# UNITED STATES PATENT AND TRADEMARK OFFICE

APPLICATION NO.	FILING DATE	FIRST NAMED INVENTOR	ATTORNEY DOCKET NO.	CONFIRMATION NO.
10/824,447	04/14/2004	Steve Karaga	051110-1010	6607

## Office Action Summary

### **DETAILED ACTION**

Jones US-355,825

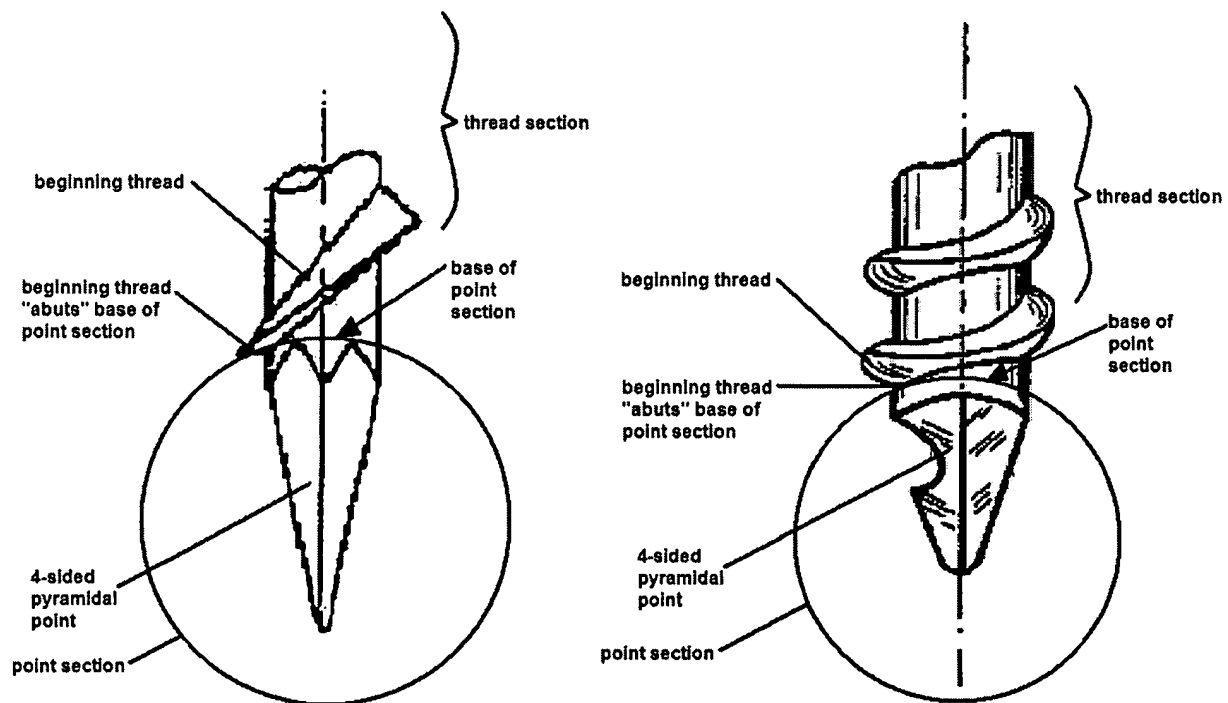
Jones US-355,825 teaches a cone-shaped or diamond-shaped point (i, pg 1 lns 73-75) in combination with a thread section (e), tapered head (g), unthread section (f), and engagable unscrew means (h). Jones uses a lesser pitch that would be within a non-obvious reach of 60-63°; however, still intends the screw to be driven via hammer blow, and released by unscrewing (pg 1 lns 85-89).

Present invention (left) Rockefeller US-4,572,720 (right)

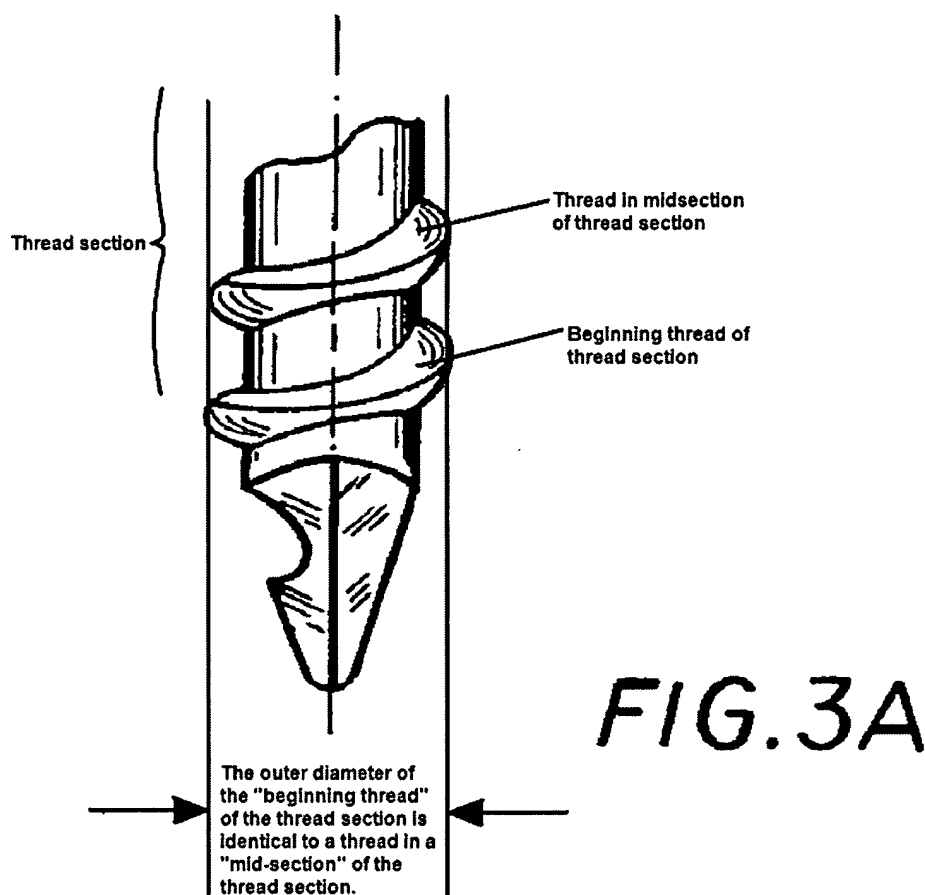
Applicant has amended the foregoing claim(s) such that (as it is understood), the point section has a point and a base. Rockefeller still suggests (as does Applicant) "threads of a thread section abutting a base of the point section". This is clearly demonstrated in the figure below.
